FIRE SAFETY INSPECTION REPORT

RIZVI FASHIONS LTD.

ACCORD
on Fire and Building Safety in Bangladesh

February 6, 2015

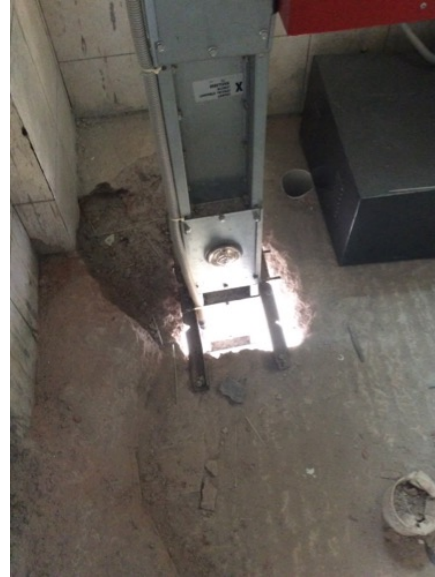
No.	Category	Finding	Recommendation	Remediation Timeframe
F-1	Fire Rated Construction	The boiler room is not separated by fire-rated construction due to openings and non-rated doors.	Separate the boiler room by a minimum 1-hr fire-rated construction for non-high rise, and 2-hr fire rated construction for high rise. Seal and/or protect all openings to maintain the required fire separations. When located to the exterior of a building, 3m (10 ft.) separation is required. Provide proper ventilation and consult a qualified engineer.	Within 3 months

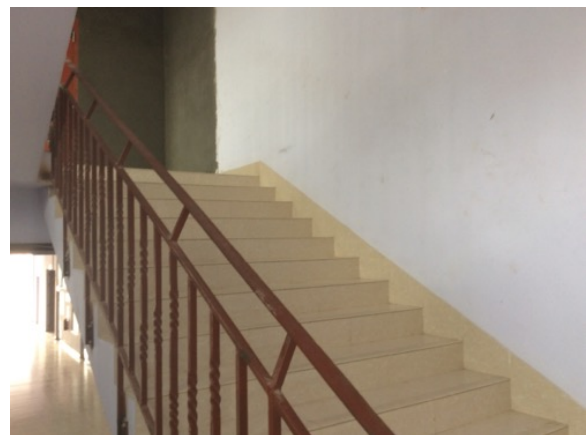
F-9	Egress	Handrails are not provided on both sides of all exit stairs on each floor.	Provide handrails on both sides of the exit stair. New handrails shall have a minimum height of 865 mm (34 in.) and a maximum height of 965 mm (38 in.) as measured from the leading edge of the tread. Intermediate handrails shall be provided when the stair width exceeds 2.2 m (87 in.).	Within 3 months
-----	--------	--	---	-----------------

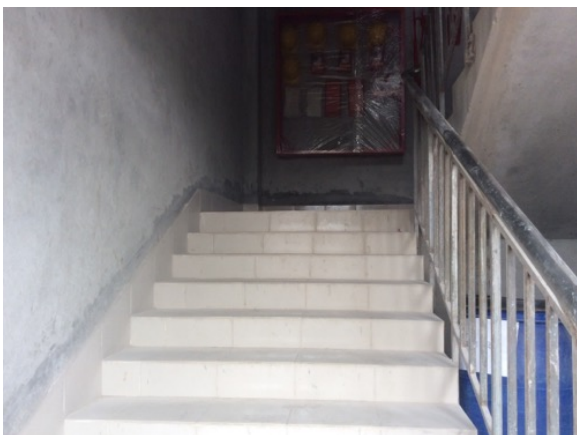
F-6	Egress	Handrails are not provided on both sides of the exit stair.	Provide handrails on both sides of the exit stair. New handrails shall have a minimum height of 865 mm (34 in.) and a maximum height of 965 mm (38 in.) as measured from the leading edge of the tread. Intermediate handrails shall be provided when the stair width exceeds 2.2 m (87 in.)	Within 3 months
-----	--------	---	--	-----------------

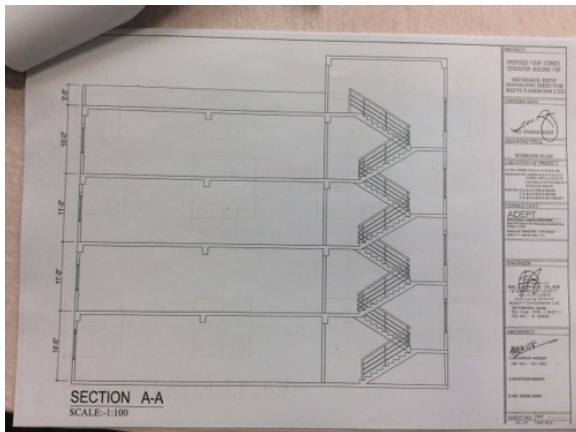
F-9	Fire Protection	Inspection, testing and maintenance of portable fire extinguishers is not in accordance with NFPA 10.	Inspect, test and maintain the portable fire extinguishers and keep written records on-site, in accordance with NFPA 10.	Within 3 months
F-10	Fire Protection	Inspection, testing and maintenance for the fire alarm system is not in accordance with NFPA 72.	Inspect, test and maintain the fire alarm system and keep written records on-site, in accordance with NFPA 72.	Within 3 months
F-11	Fire Protection	Inspection, testing and maintenance of the standpipe system is not in accordance with NFPA 14.	Inspect, test and maintain the standpipe system and keep written records on-site, in accordance with NFPA 14.	Within 3 months
F-12	Fire Protection	The required standpipe system is not installed in accordance with the ACCORD standard.	Install a new standpipe system in accordance with ACCORD standard 5.4 and NFPA 14. A class III system shall be installed in buildings with the highest occupiable floor 10 m (33 ft.) above grade or more. A class I system shall be permitted in buildings protected throughout by an approved automatic sprinkler system.	Within 6 months
